Access Compliance Report Public Rights-of-Way (Curb Ramps)

Main Street: PEMBERTON_RD Cross Street: HARRISBURG_RD Location: NE

ADA ID: RPRK211215120511 Ramp Type: Type 1 - Perpendicular Diagonal Initial Pass/Fail: Fail Overall Compliance: No Severity Score: 16

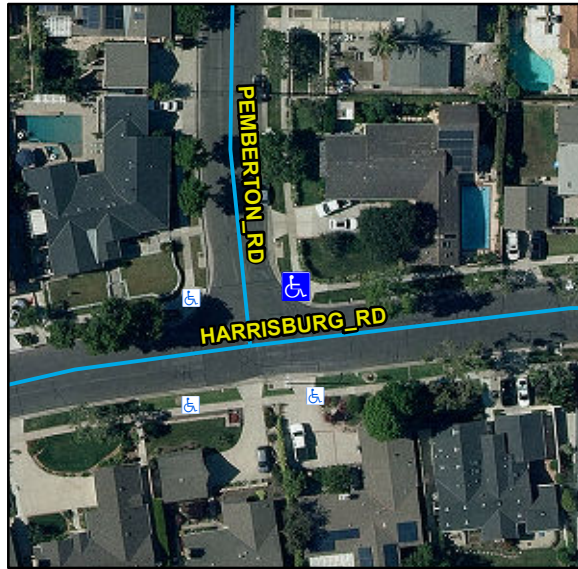
Compliance	Description	Data	Compliance	Description	Data
N/A	Ramp Length (in)	84	N/A	Flare Type LT	
Yes	Ramp Width (in)	48			N/A
No	Ramp Run Slope (%)	9	N/A	Flare Slope LT (%)	N/A
Yes	Ramp Cross Slope (%)	2	N/A	Flare Traversable LT	N/A
N/A	Landing Present	N/A	N/A	Flare Type RT	
N/A	Landing Length (in)	N/A			N/A
N/A	Landing Width (in)	N/A	N/A	Flare Slope RT (%)	N/A
N/A	Landing Run Slope (%)	N/A	N/A	Flare Traversable RT	N/A
N/A	Landing Cross Slope (%)	N/A	N/A	DWS Provided	N/A
N/A	Landing Movement Obstructed?	N/A	N/A	DWS Contrast	N/A
	Landing Movement Type	N/A	N/A	DWS Length (in)	N/A
N/A	Landing Shared	N/A	N/A	DWS Full Width	N/A
N/A	Clear Space	Yes	N/A	DWS Offset Left (in)	N/A
N/A	Clear Space To Crosswalk (in)	N/A	N/A	DWS Offset Right (in)	N/A
N/A	Marked Crosswalk 1	No	N/A	Marked Crosswalk 2	No
	Crossing 1 Direction	W		Crossing 2 Direction	S
	Marked Crosswalk 1 Width (in)	N/A		Marked Crosswalk 2 Width (in)	N/A

N/A	Ramp Inside Crosswalk 1	N/A	Yes	Ramp Inside Crosswalk 2	N/A
	Crossing 1 Slope (%)	6.8		Crossing 2 Slope (%)	8.4
	Crossing 1 Cross Slope (%)	1.1		Crossing 2 Cross Slope (%)	0.3
N/A	Gutter Ponding	N/A	No	Curb Slope	11.3
Yes	Gutter Lip Height (in)	0		Road Run Slope (%)	0.4
N/A	Gutter Run Slope (%)	N/A		Road Cross Slope (%)	9.4
N/A	Gutter Cross Slope (%)	N/A			
Yes	Overall Surface Condition: Acceptable		No	Perp Joint Present	No
	Cross Gutter Present?	No		Spandrel Present?	No
	Replace Cross Gutter?	N/A		Replace Spandrel?	N/A

Remove & Replace Curb Ramp With Two New Directional Ramps or Equivalent.

R304.2.2, R204.3, STD 1115
